## PRODUCT DISCONTINUATION

### #PD-ICT-MBM9-12

Business Unit	Product Line Code	Type of Change	Action	Date of issue
ICT	BF1	Discontinuation	Notify Distributors and Field	6/5/2012

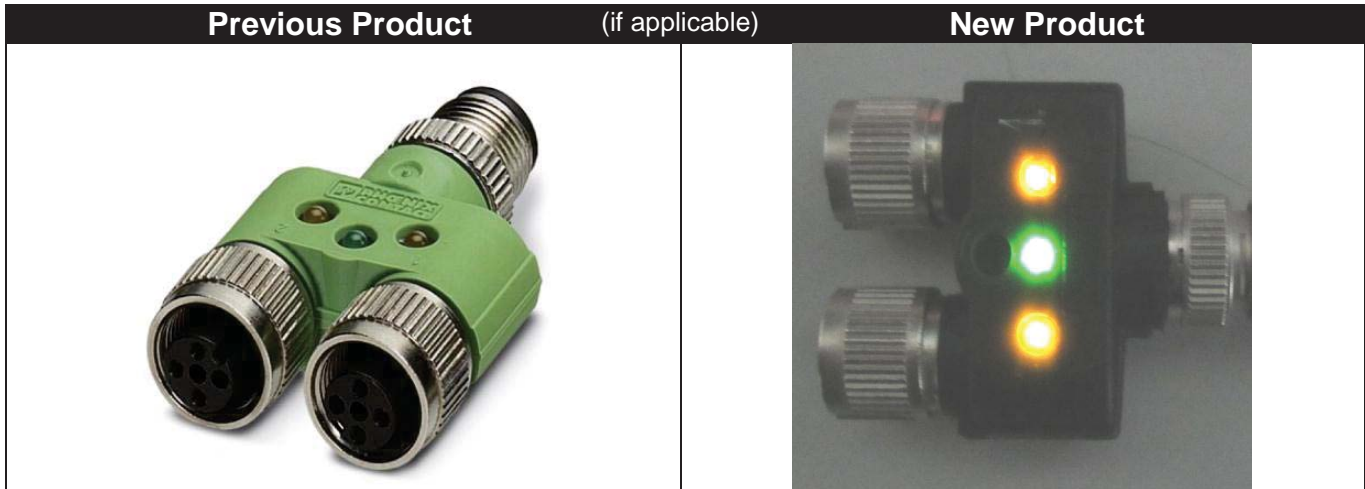
The exposed LEDs are now over molded with a translucent material. This provides better integration of the LEDs into the connector body. The color of the over mold has also changed from green to black.
